Tresillian WOLLSTONECRAFT
C/- Donald Cant Watts & Corke
Level 1 - 14 Martin Place
SYDNEY, NSW 2000
P: 9922 4500

TREE 35 – SITE DRIVEWAY ACCESS MODIFICATION ARBORICULTURAL ADDENDUM REPORT

Ref No: RTC-11518

Figure 1, driveway design & TPZ area

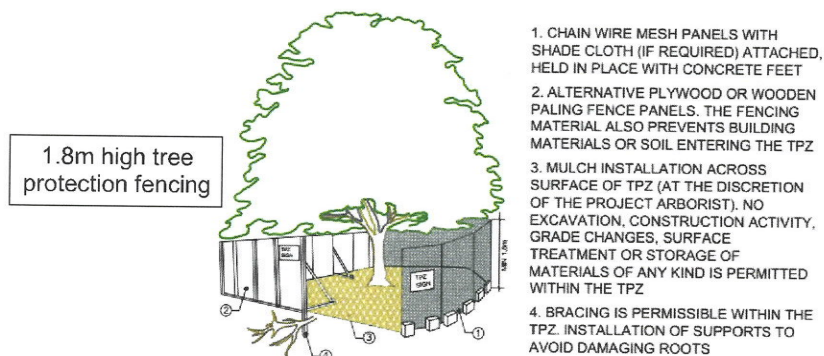
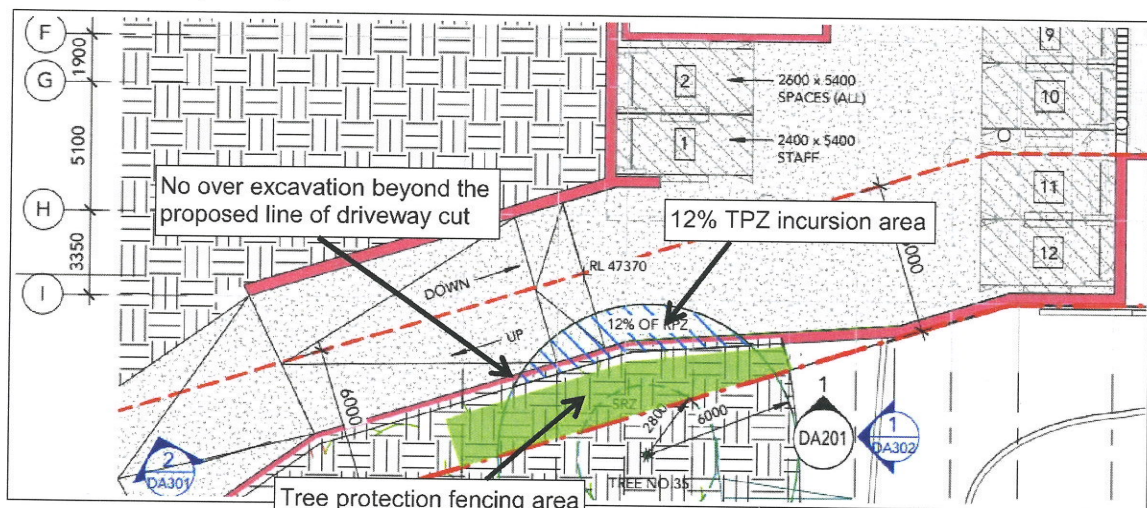
- 1.1 The new modification in driveway design occupies a low level (12%) incursion within the trees 6m Tree Protection Zone (TPZ) with no works occurring within the 2.8m Structural Root Zone (SRZ).

With low level TPZ occupancy a negligible impact by the proposal occurs with appropriate tree management recommended to be conducted prior, during and post construction activities.

3. From the boundary fence line 1.8m high tree protection fencing is to be placed at a minimum 2m setback adjacent the tree. The tree protection fencing is to extend to the limit of the 6m TPZ radius to the south and 7m to the west as shown within Figure 1 p2. The TPZ is to be maintained as specified within AS4970 Section 4.6 *Maintaining the TPZ* such as providing leaf mulch, irrigation and excluding development and access within the TPZ area.

4. To ensure no additional TPZ encroachment occurs there is to be no over excavation beyond the line of the proposed driveway cut as shown within construction drawings. Contiguous or sheet metal piling is recommended with the excavation type recommended to be detailed within final construction plans.
